Smoky Canyon Mine

Pilot Study Work Plan and Sampling and Analysis Plan

Addendum 03 – September 2015

Pilot Test Plan: Bioreactor Post Treatment with Oxidant
Frontier Water Systems (August 26, 2015)

Selenium Treatment Plant Overview

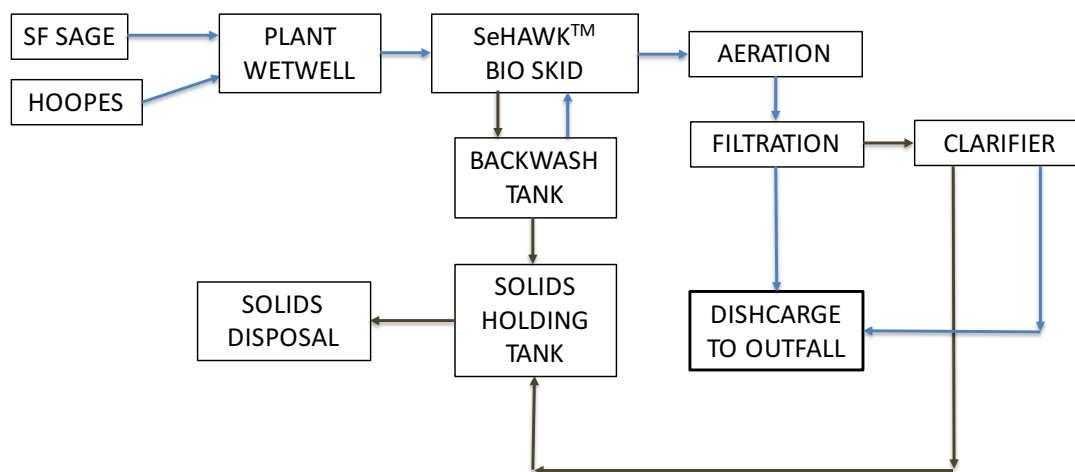
Following selenium removal, the water is subject to aeration to strip off any residual sulfide and add dissolved oxygen back to the water. The aeration step is effective in accomplishing both of these goals, but has been cultivating filamentous sulfide oxidizing bacteria, which have been identified as Thiothrix Type 1 bacteria. Thiothrix is problematic as it forms long filaments that impart a high solids load on the downstream sand filter, clogs the filter media, and attaches to rocks at the outfall. Further, the excess biomass load can impart an oxygen demand following the aeration, and create reducing conditions that can mobilize iron in the filter. A process flow schematic of the plant is provided below.

Thiothrix and other sulfide oxidizing bacteria can be controlled by removing the sulfide from the stream prior to aeration. Sulfide can be removed by application of an oxidant treatment such as hydrogen peroxide or ozone.

In the scope of this pilot test, it is proposed to test oxidative treatment to remove sulfide directly from the selenium treatment plant effluent as it discharges to the aeration unit. This oxidative treatment will remove residual sulfide by converting it back to sulfate. It is proposed to use 27% hydrogen peroxide, which would be delivered directly to aeration tank, which is receiving the bioreactor effluent. Following the sulfide oxidation, residual peroxide will be consumed by the aeration unit, and the downstream sand filter.

- Procure and install chemical feed skid for peroxide dosing
- Procure Hydrogen Peroxide feed tote (SDS attached)
- Install of peroxide injection point to aeration stage
- Install pH probe caustic injection point to bioreactor discharge
- Update PLC/HMI code to include pH control loop control integration for pH control and optimization
- Controls integration for chem feed system to include dose control/flow pacing
